COMMITTEE OF THE WHOLE SEPTEMBER 15, 2003

**ZONING BY-LAW AMENDMENT FILE Z.03.061
SITE DEVELOPMENT FILE DA.03.014
1541677 ONTARIO LIMITED**

Attachment 2
FILE No.: DA 03.014
RELATED FILE: Z.03.061
August 26, 2003

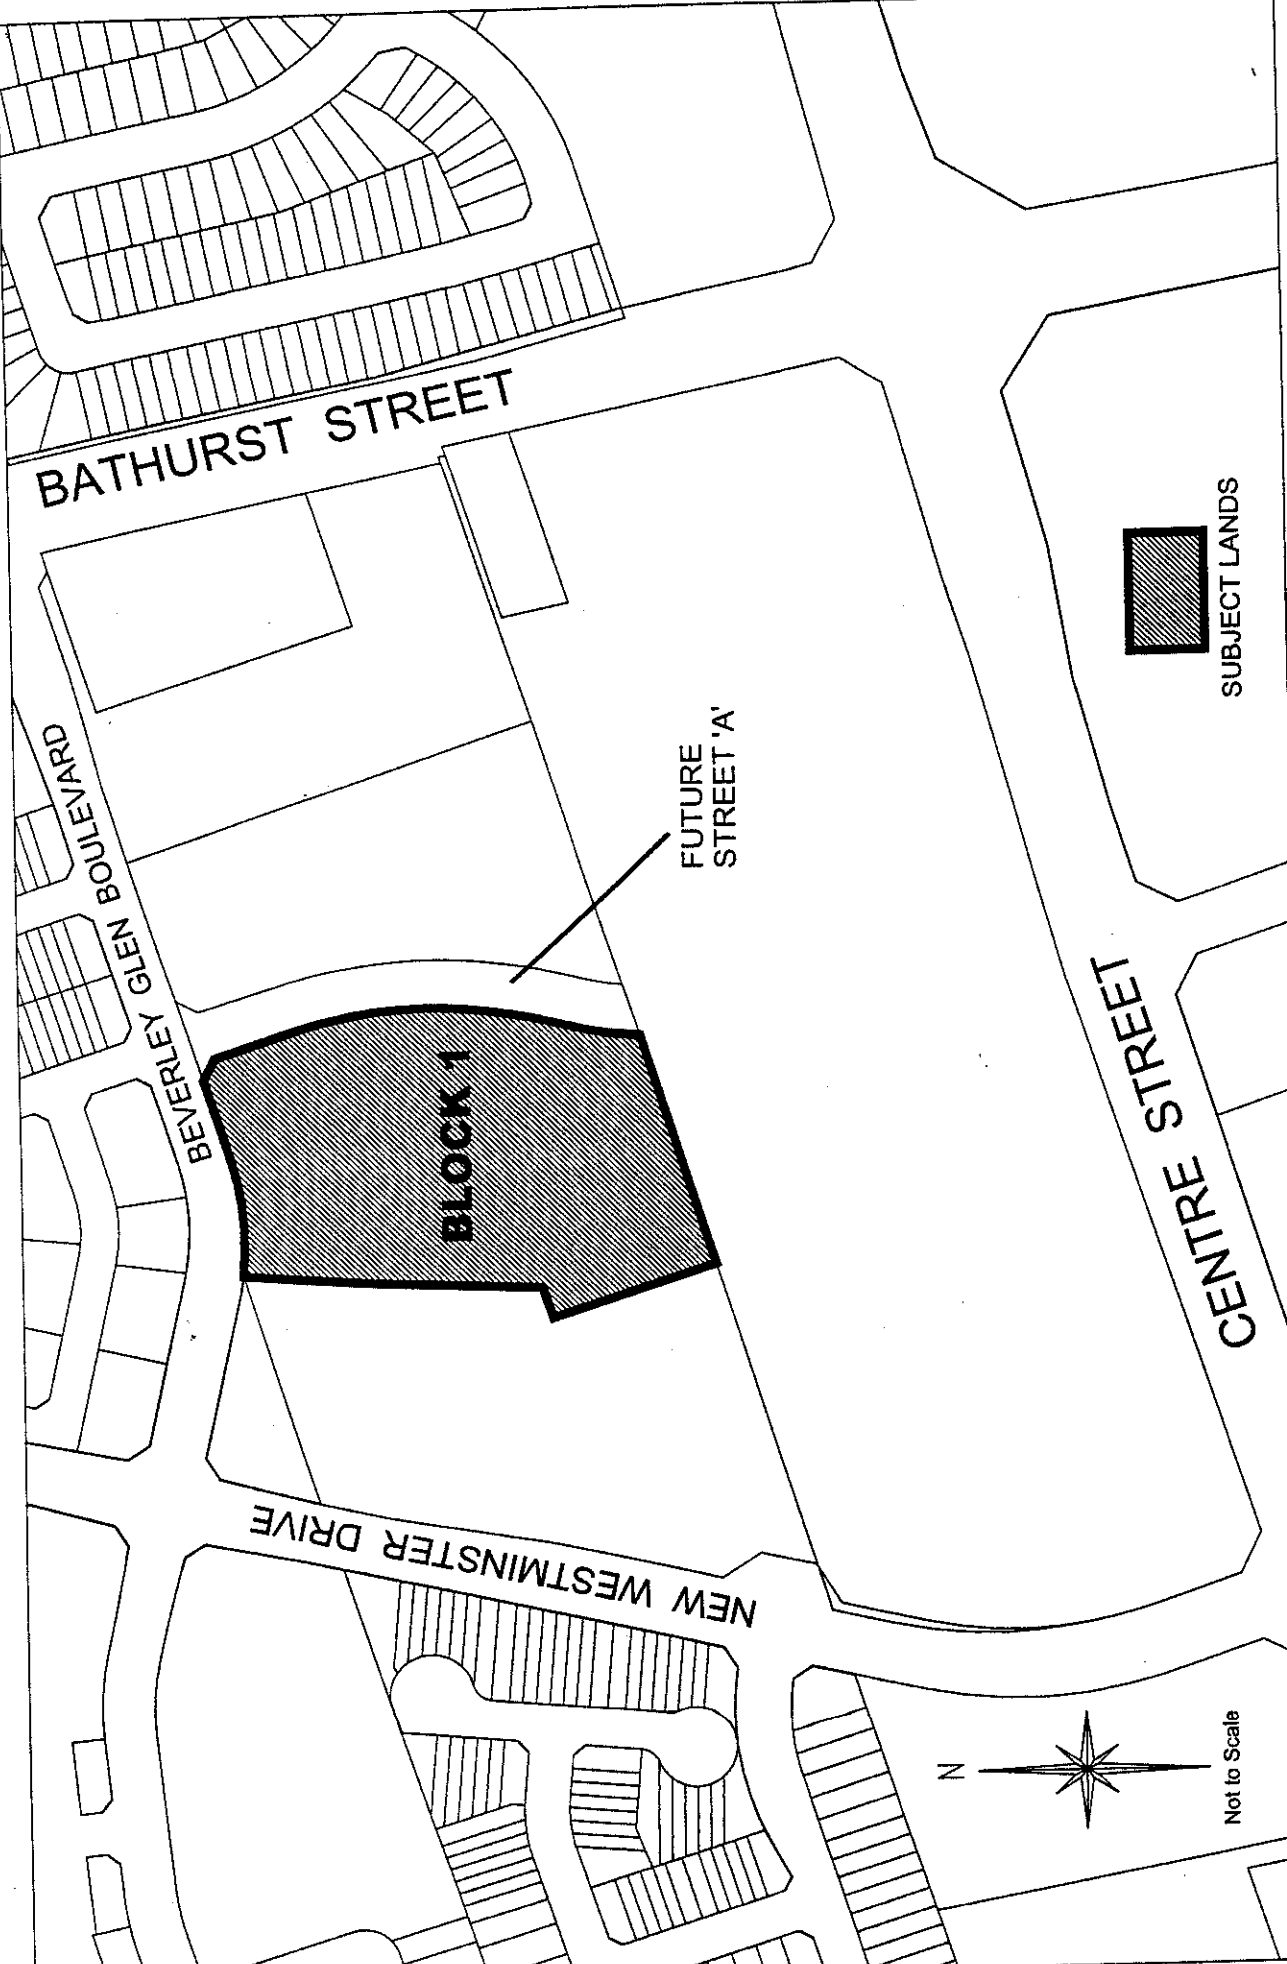
The Engineering Department has reviewed the site plan and underground parking drawings and requires the following revisions:

- the width of the barrier-free parking spaces shall be 3.9m, and not 3.6m as shown; and,
- underground parking spaces have been identified that do not permit vehicles to have proper turning radii, and shall be revised accordingly.

The landscape plan shows a 1.5m high decorative metal picket fence with brick and precast concrete piers along the east property line, and includes a matching brick and precast concrete entry wall at the east driveway access to the site. Staff recommends that the same treatment be incorporated along the north lot line and north driveway access.

Elevations

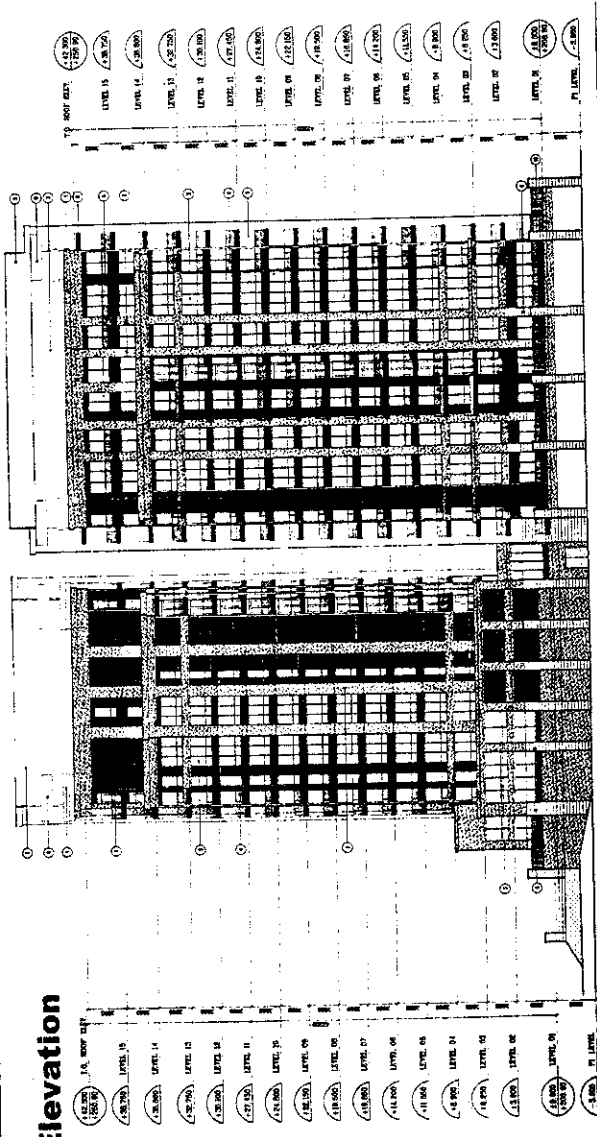
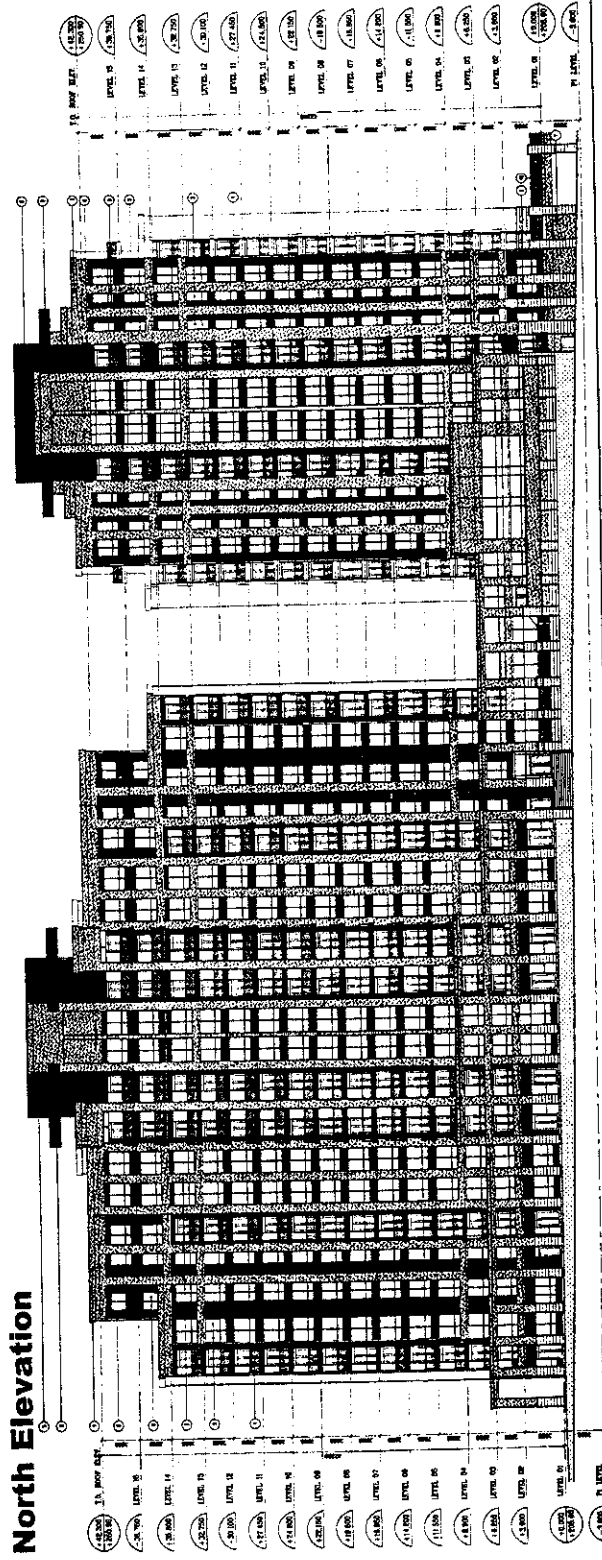
The Urban Design Department provides the following comments respecting the building elevations:

- the resident/guest entry point from the future east/west street is to be considered a primary resident and visitor entry point, and as such, the 'canopy' should be revised to be a strong, well defined architectural feature that is clearly identified from the street;
- indicate the extent of the canopy cover on the ground floor plan; and,
- include shade/shadow effects on the coloured elevation drawings to assist in defining the building articulation.

Landscape Plan

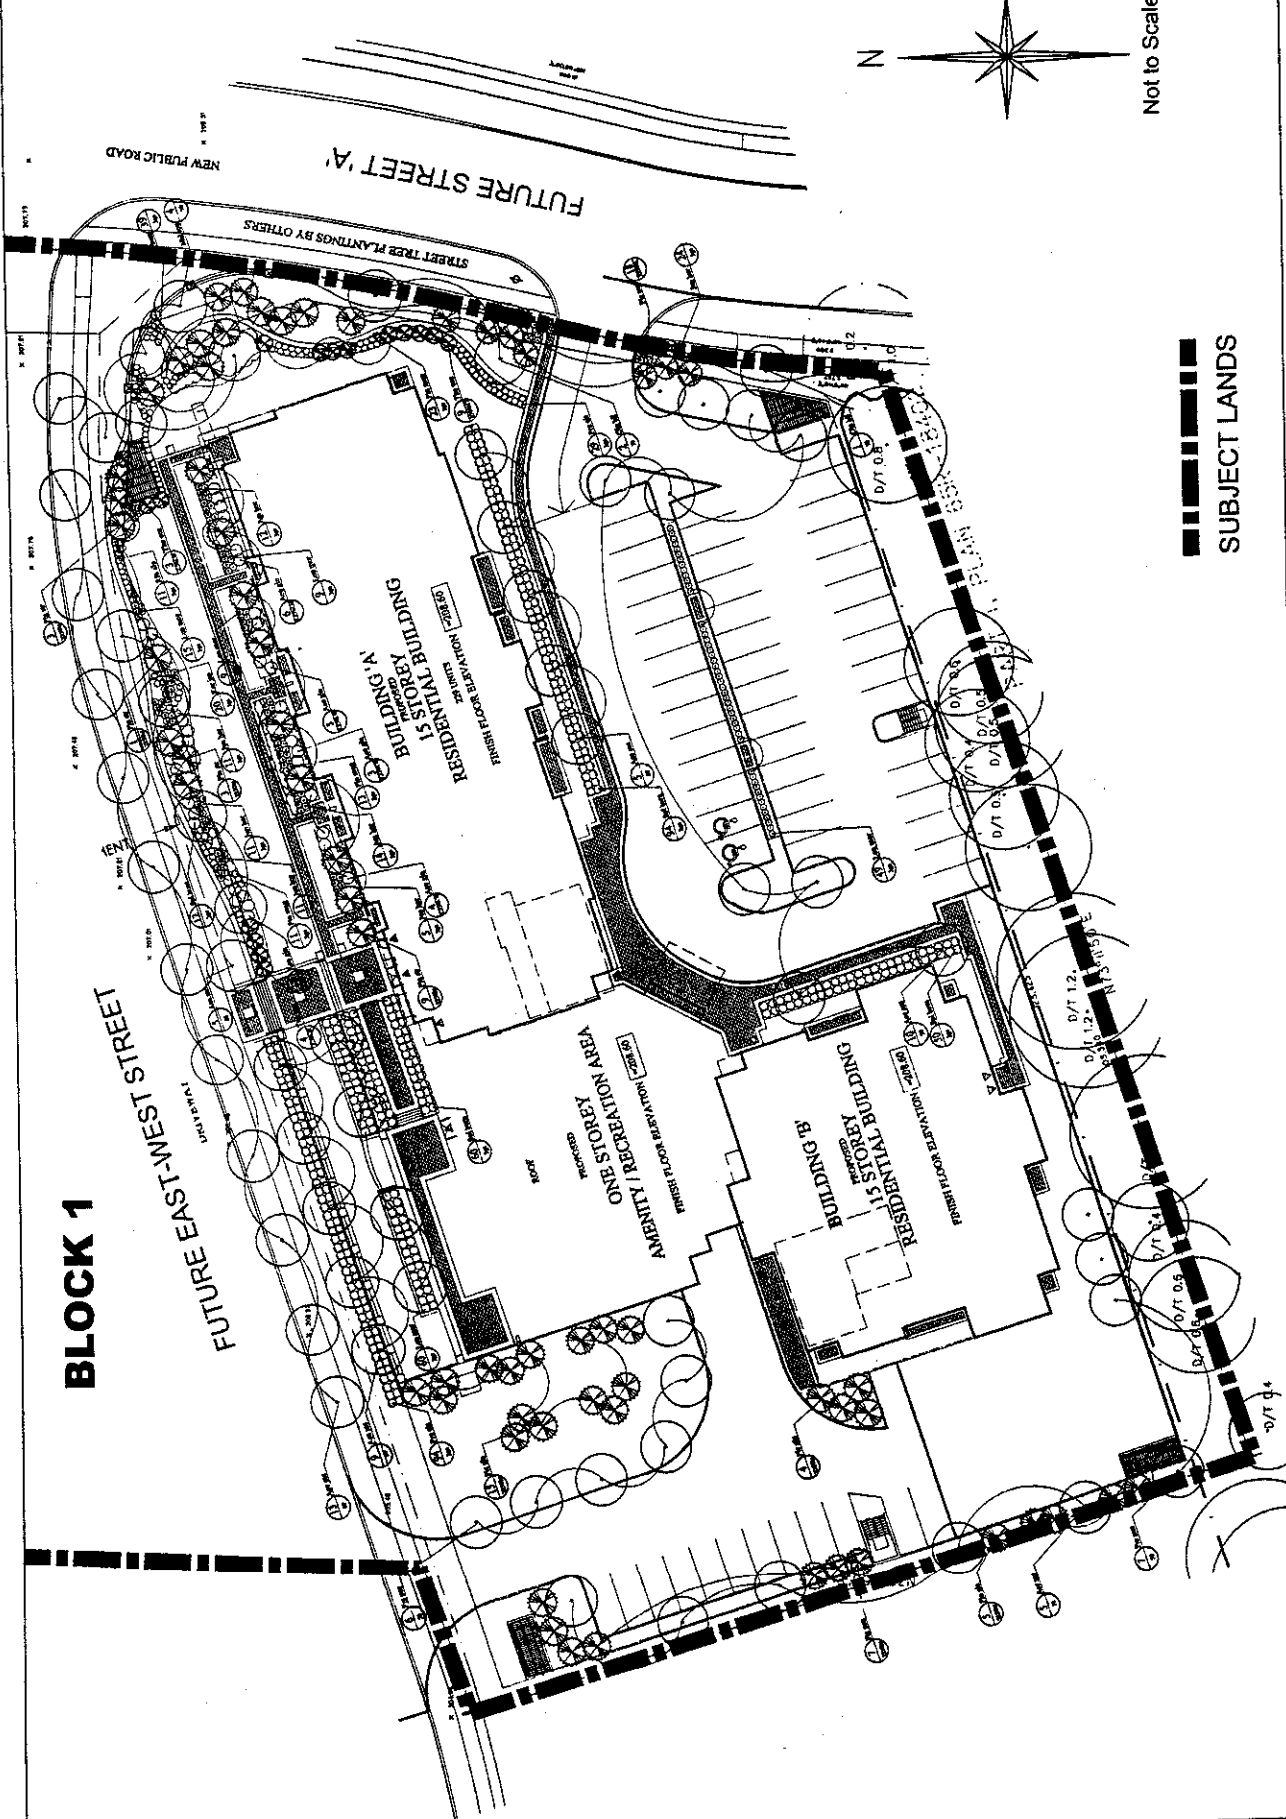
The Urban Design Department provides the following comments regarding the landscape plan:

- the 1-storey roof decks (above lobby and underground ramp) is to shall be treated as part of the landscape amenity of the buildings, to be used as a secure, accessible outdoor amenity space for the residents;
- suggest increasing the width of the outdoor patios to 3m;
- show all site lighting (pedestrian, parking area, etc.) on the drawing;

- show site servicing (including transformers and switchgears);
- extend pathways from common walkway out to the proposed municipal sidewalk;
- consider using plant species that are less dense and shorter in front of the unit windows to maximize views out and allow light in;
- extend and enhance the landscape detail beyond the wall to the intersection at the northeast corner of the site; and,
- continue and enhance the landscape detail along the west lot line, including the northwest corner of the site.
